Product Change Notification / LIAL-15QPNY176

CCB 4506 Initial Notice: Qualification of MMT as an additional assembly site for selected products available in 8L TDFN (2x3x0.8mm) package.

CCB 4506
Pre and Post Change Lead Frame Comparison
PCN # LIAL-15QPNY176

Lead frame comparison

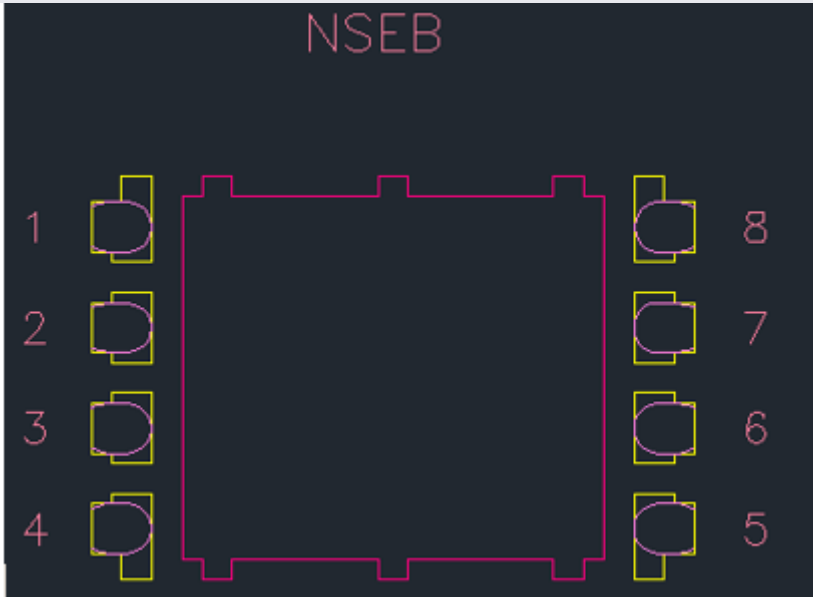
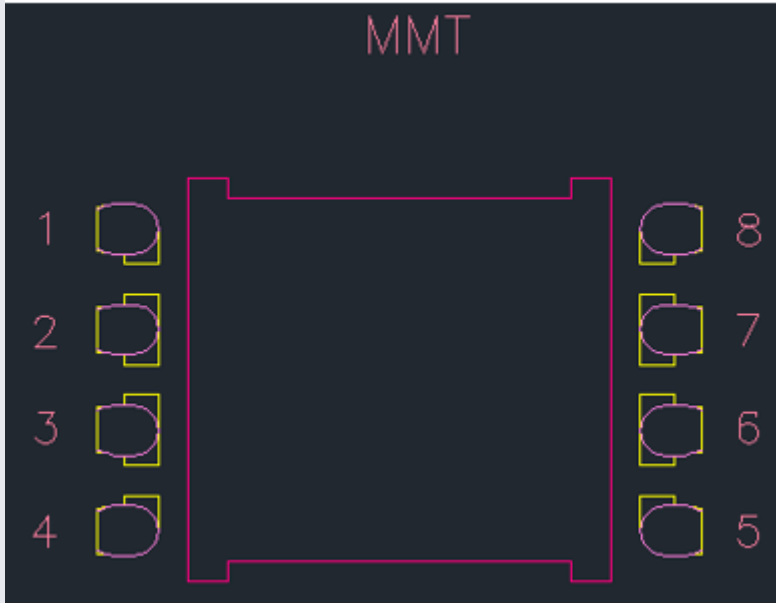
Revision History:**December 21, 2020:** Issued initial notification.**January 19, 2021:** Re-issued initial notification to update the pre and post change summary to correct the lead frame lead lock of NSEB from Yes to No.

Pre change	Post Change				
NSEB	MMT				
 The diagram shows a top-down view of an NSEB (Normal Single End Board) lead frame. It features a central rectangular body with a pink outline. On the left and right sides, there are four pins each, numbered 1 through 4 on the left and 8 through 5 on the right. The pins are yellow with purple outlines. The text 'NSEB' is written in pink at the top of the diagram.	 The diagram shows a top-down view of an MMT (Micro Miniature Technology) lead frame. It features a central rectangular body with a pink outline. On the left and right sides, there are four pins each, numbered 1 through 4 on the left and 8 through 5 on the right. The pins are yellow with purple outlines. The text 'MMT' is written in pink at the top of the diagram.				
<table><tr><td>Lead frame lead-lock</td><td>No</td></tr></table>	Lead frame lead-lock	No	<table><tr><td>Lead frame lead-lock</td><td>No</td></tr></table>	Lead frame lead-lock	No
